# 21150 PCI-to-PCI Bridge

Specification Update

*October 2001*

Order Number: [278258-009](#)

**Figure 1. S\_Clock Multiplexer Workaround Circuit for Errata 6.**

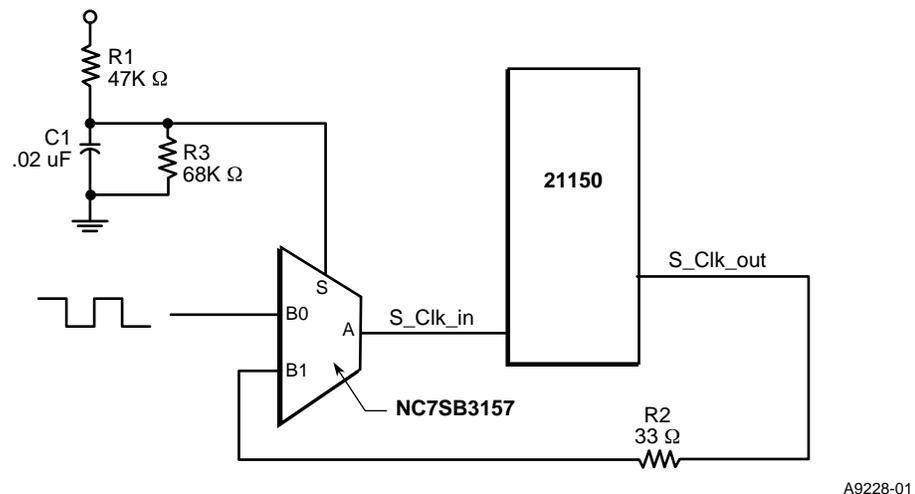
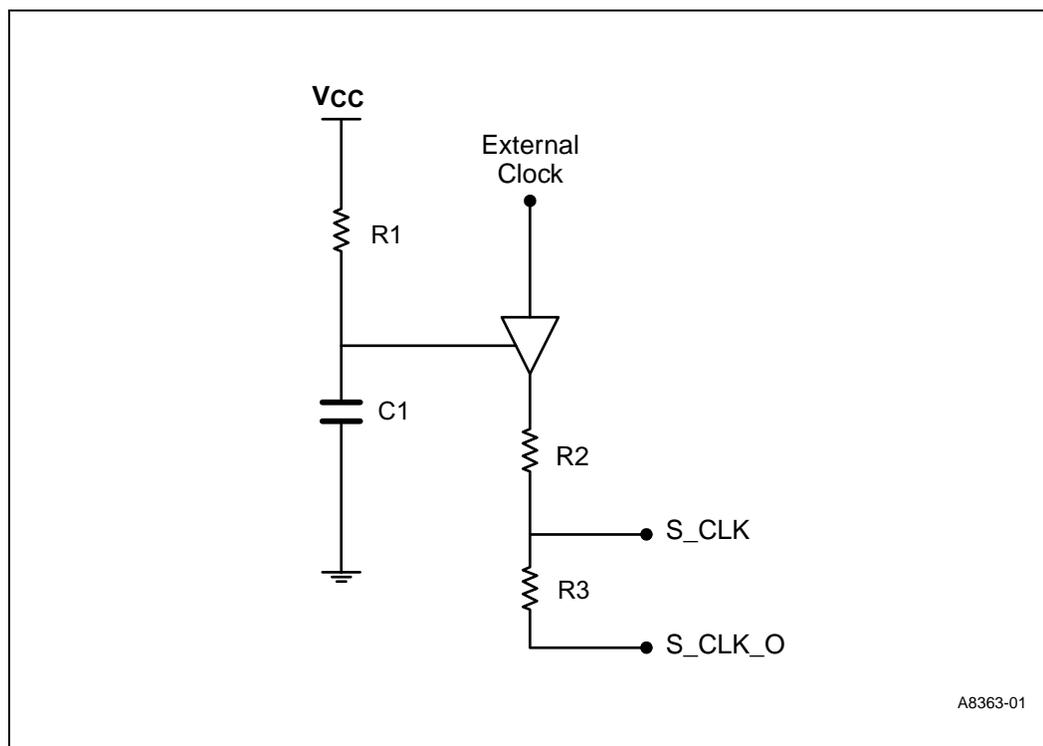
**Implication:** In a system with a 21150AC or 21150BC that has one of its s\_clk\_o<9:0> outputs fed back to provide the s\_clk, it is possible that the s\_clk\_o<9:0> output clocks will be driven and remain low, keeping s\_rst\_l asserted, during system power up.

This happens occasionally when a latch whose output disables the serial shift registers on the Secondary clock control powers up in a high state and the shift register bit corresponding to the s\_clk\_o<9:0> output that is fed back also powers up in the high state.

1. [Figure 1](#) illustrates the first recommendation - a circuit where an on-board pulse source is gated via the B0 input of the multiplexer to the S\_Clock\_in pin of the 21150.

At time 0, the S input of the multiplexer is low, allowing pulses from the on-board pulse source, connected to the B0 input, to be provided to the 21150 S\_Clk input pin. When the time determined by the R/C network is satisfied, the S input pin will be in a logic High state. The Multiplexer will then shut off the input pulse from S0 and will direct the S\_Clock\_out pulses via the B1 multiplexer input, into S\_Clock\_in.

The values used for the R/C network should be selected to allow a minimum of 2 pulses to be delivered to the 21150 after V<sub>dd</sub> has reached 3.0V at a frequency not to exceed the appropriate PCI component. i.e. 30 ns for a 33Mhz bridge. These values should be chosen based on the rise time of the power supply and the frequency of the on board pulse source. The values given for R1, R3, and C1 are for example purposes only.

**Note:** The NC7SB3157 2:1 Multiplexer / Demultiplexer Bus Switch used in this example has a maximum propagation delay of 800ps that should be taken into consideration when matching trace lengths of the clock lines to avoid introducing excessive skew in the clocks. All S\_Clock etch lengths must be matched to within 2ns @ 33Mhz or 1ns @ 66Mhz. The addition of this circuit requires that the etch length for the S\_clock\_in signal be reduced to compensate for the 800ps delay.

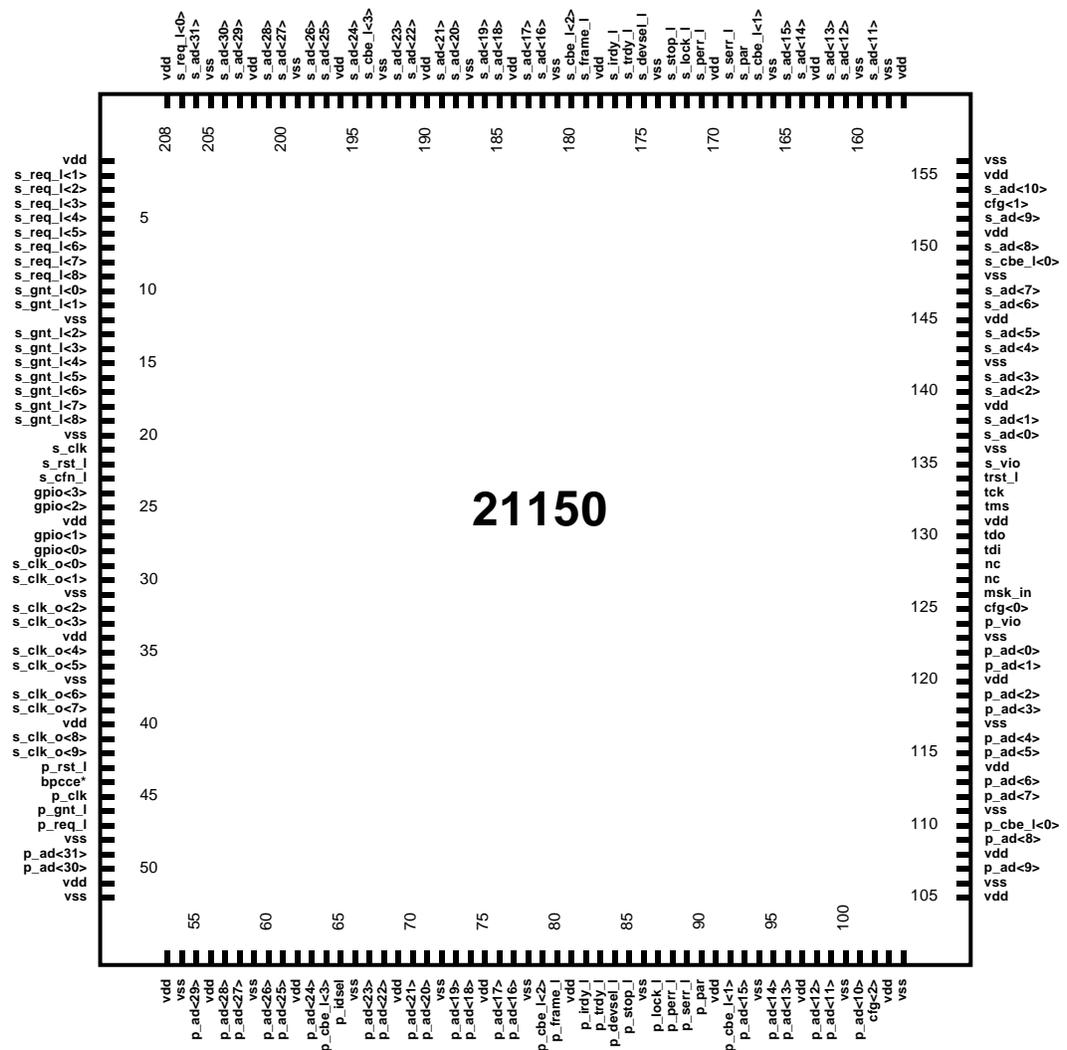
## 1. Section 3.0, Figure 5, 21150 Pin Assignment

Pin 44 should be designated bpcce\*. The following note should be added to the drawing: \*For 21150AB and later revisions only. This is a vss pin for the 21150AA.

\* For 21150-AB and later revisions only.  
This is a vss pin for the 21150-AA.

**Figure 20. Clock Mask and Load Shift Timing**

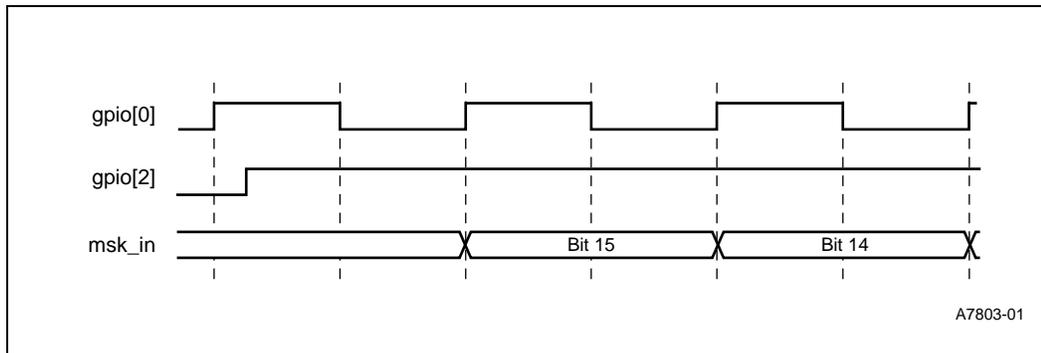
2. **Section 10.2, Secondary Clock Control, Figure 20**

This figure now appears as follows:

**Figure 4. Signal trst\_l States**

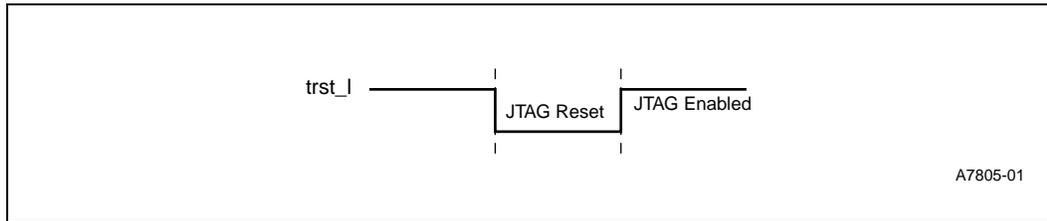
**6. Section 5.1, Initialization, Description**

This section has been changed to:

The test access port controller and the instruction register output latches are initialized and JTAG is disabled while the trst\_l input is asserted low (see [Figure 4](#)). While signal trst\_l is low, the test access port controller enters the test-logic reset state. This results in the instruction register being reset which holds the bypass register instruction. During test-logic reset state, all JTAG test logic is disabled, and the device performs normal functions. The test access port controller leaves this state only after trst\_l (low) goes high and an appropriate JTAG test operation sequence is sent on the tms and tck pins.

During normal 21150 operation the JTAG logic must be disabled by pulling trst\_l low using a 5K resistor.

**Figure 2. Removal of pull-down resistor for JTAG testing**

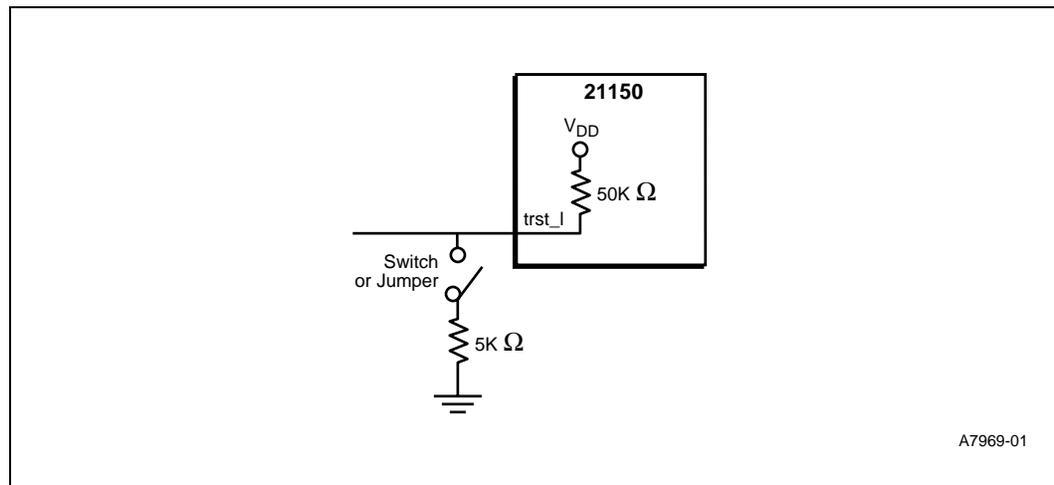
**10. Section 6.3.1, Signal trst\_l Pull-down Resistor, new section**

A 5 K  $\Omega$  pull-down resistor is required on trst\_l for normal PCI-to-PCI bridge operation. However, some JTAG test results may be inconclusive if the 5 K  $\Omega$  resistor remains in the circuit. To obtain accurate JTAG results, Intel recommends one of the following solutions:

- Verify that the JTAG test equipment, after driving trst\_l low to reset the TAP controller, constantly drives trst\_l high during JTAG tests. If this signal is not constantly driven high, the 5 K  $\Omega$  resistor will pull the signal to a low state.
- Remove the 5 K  $\Omega$  resistor during JTAG tests. This resistor must be installed during normal PCI-to-PCI bridge operation.
- Design external circuits with a switch or jumper to isolate the 5 K  $\Omega$  resistor during JTAG tests (see [Figure 2](#)). This switch must enable the resistor during normal PCI-to-PCI bridge operation.

**Figure 19. Example of gpio Clock Mask Implementation on the System Board**

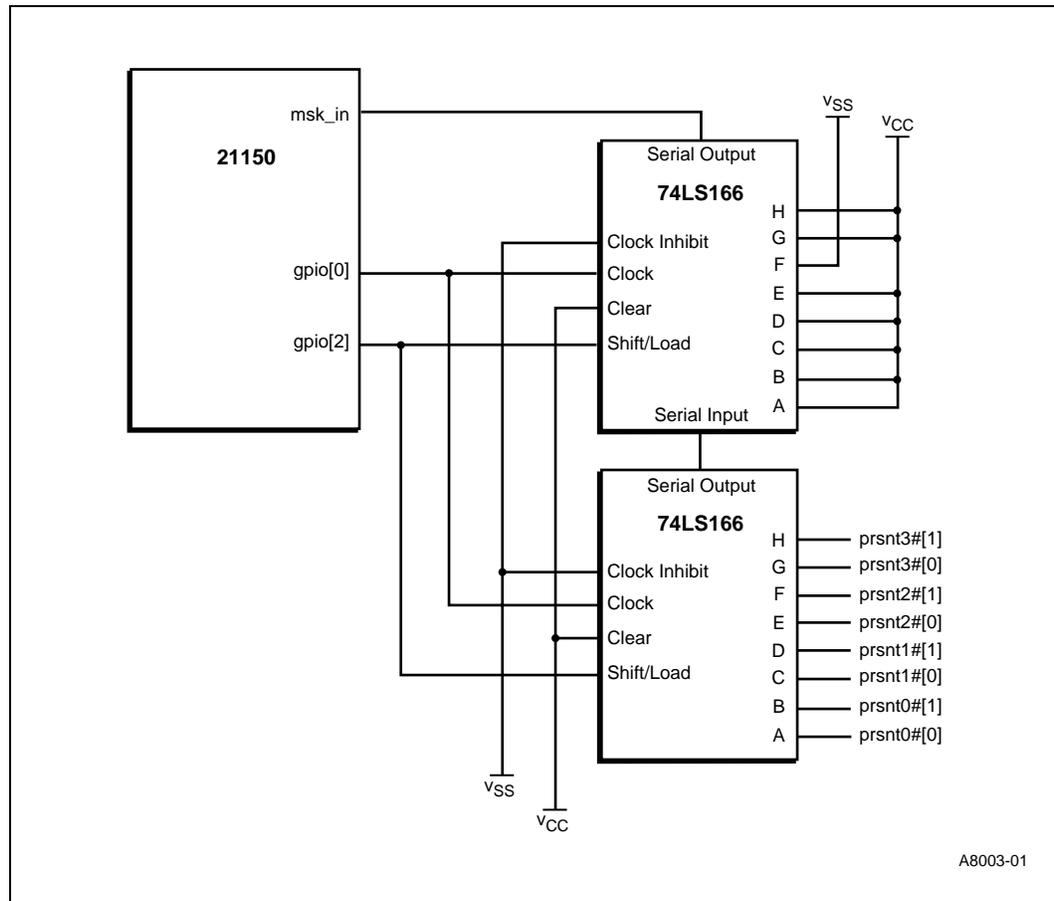
**12. Section 10.2, Secondary Clock Control, Figure 19**

This figure now appears as follows:
